ADDENDUM NO. 1

Shop Office Retrofit

June 7, 2023

Owner: Clackamas Soil and Water Conservation District

E4 -- SHOP RETROFIT - Drawing 4.1 - Revised Electrical Component Locations

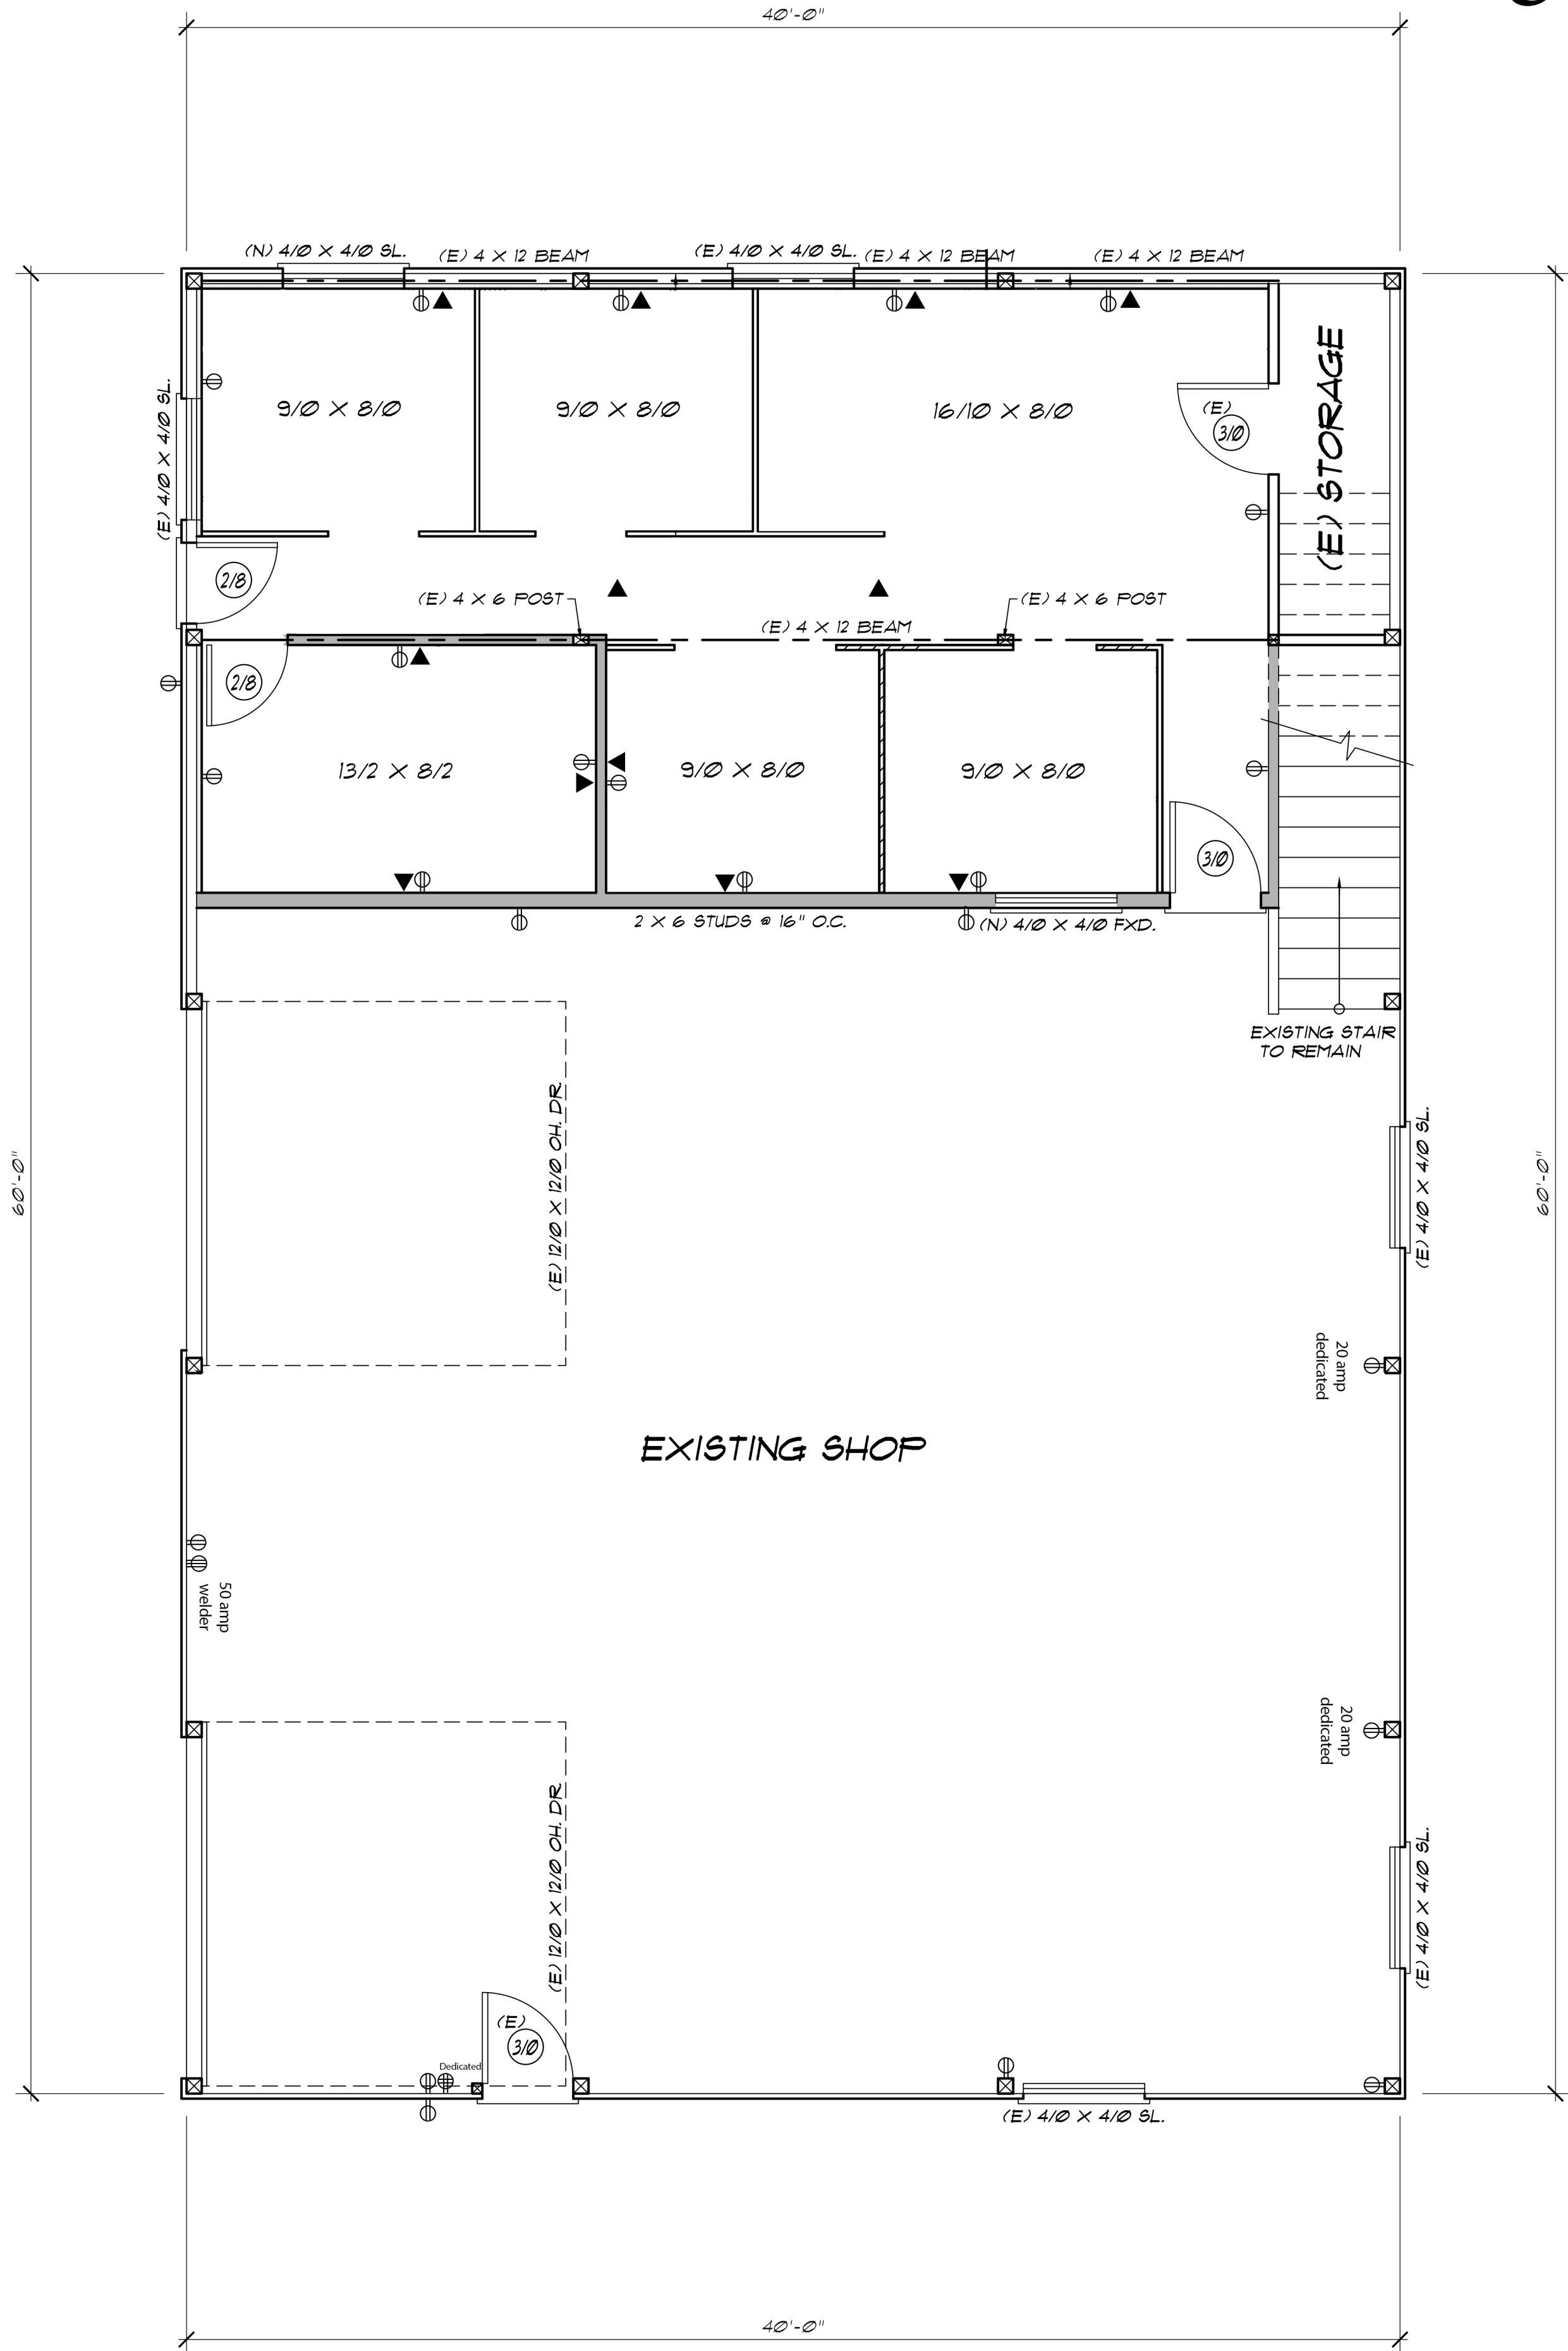
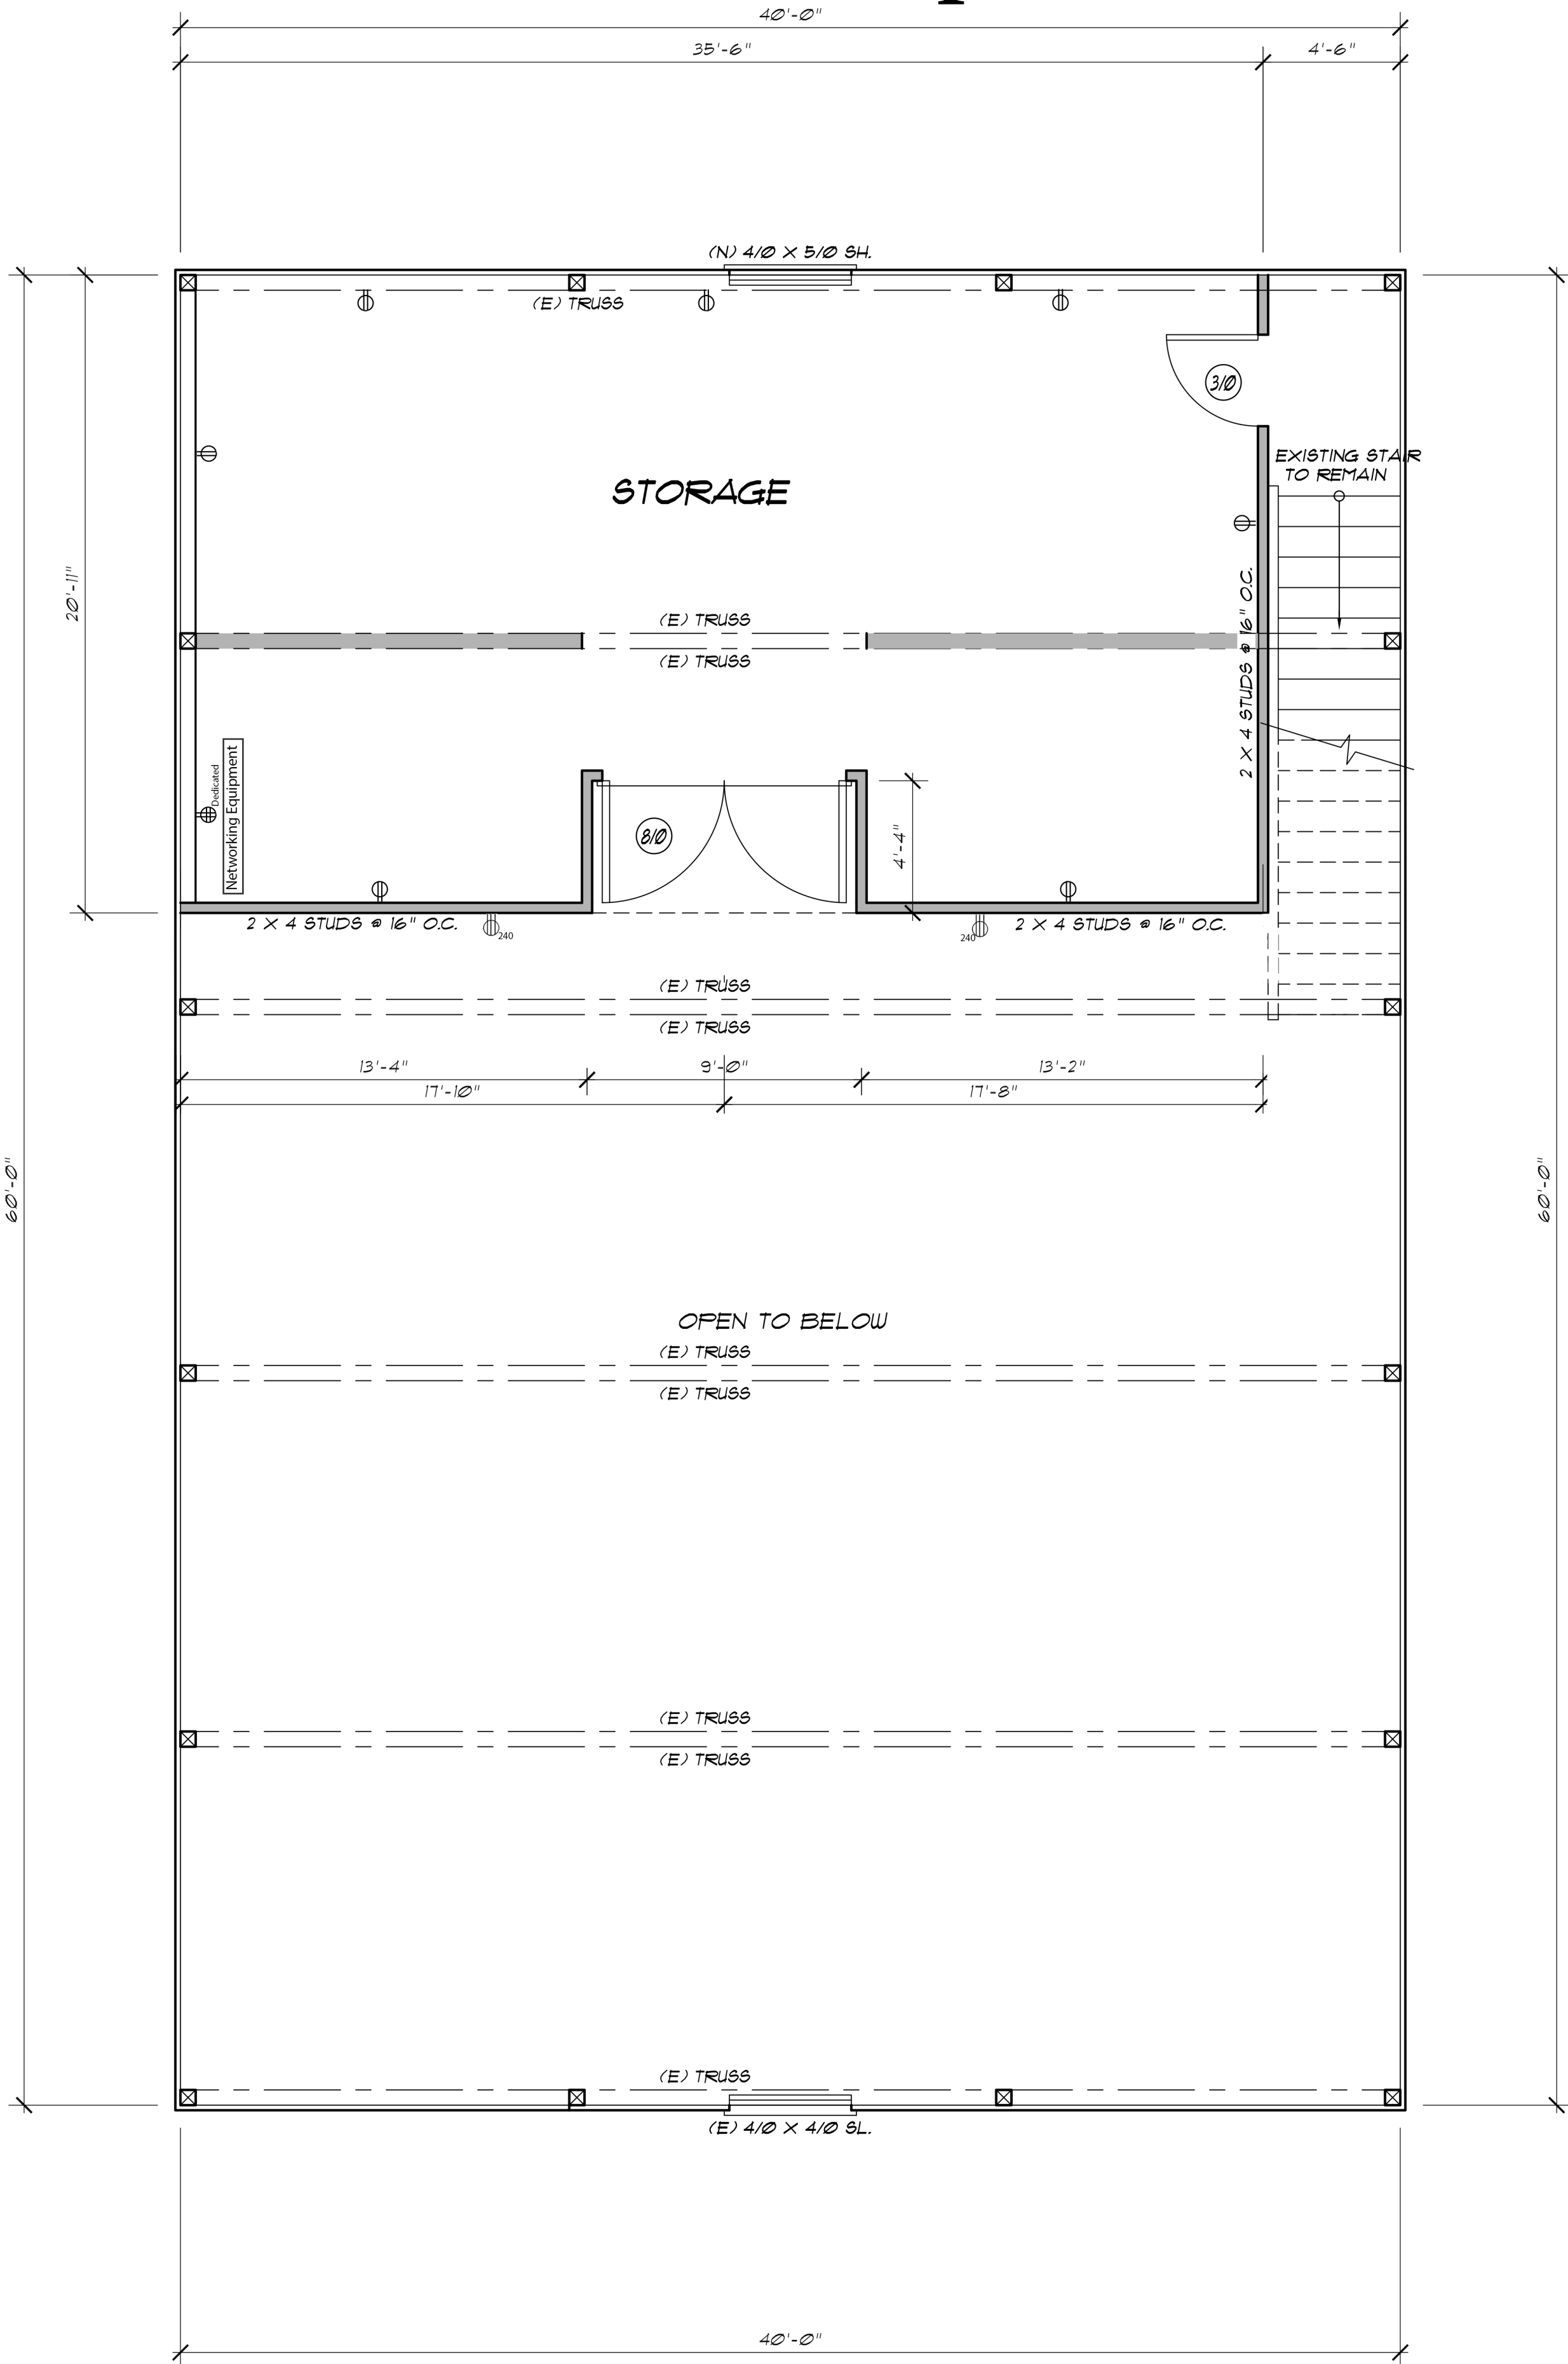
- **(Revised)** Add 2 dedicated 20-amp outlets on west wall of shop as shown on revised drawing
~~Add 2 dedicated 20-amp outlets on shop side of new wall partitioning office from shop~~

- **(Revised)** Add 2 20-amp weatherproof outdoor outlets on shared dedicated circuit with metal bubble cover as shown on revised drawing ~~Add 1 dedicated 20-amp weatherproof outdoor outlet with metal bubble cover between new entrance door and south garage door~~

- Add motion sensors for office, storage, and conference room light switches
- Add dedicated Quad receptacle for upper floor networking components
- **(New)** Add dedicated Quad receptacle near electrical panel for networking components as shown on revised drawing

- On upper floor storage, all shop lights will switch on at the entry point
- **(Revised)** New 240-volt 50 amp welder receptacle will be added between garage doors on the shop building interior and will be enclosed in a metal box with ability to lock with padlock ~~New 240-volt receptacle will be added between garage door on the building interior and will be enclosed in a lock box~~

- **(New)** All remaining outlet locations in main shop interior can be installed on shared 20 amp circuit(s) at electrician's discretion. There are 6 non-dedicated outlet locations indicated on the revised drawing.

The original drawing, named “E3 -- SHOP RETROFIT - Drawing 4 - Electrical Component Locations” has been modified to show electrical components in the shop space outside the main area of construction that are needed to assess the electrical panel capacity and estimate the cost of materials to provide those outlets.

Please disregard the original drawing entitled “E3 -- SHOP RETROFIT - Drawing 4 – Electrical Component Locations” and base your bid on the revised drawing included in the attachment below entitled “E4 -- SHOP RETROFIT - Drawing 4.1 – Revised Electrical Component Locations” (also available to download at: conservationdistrict.org).
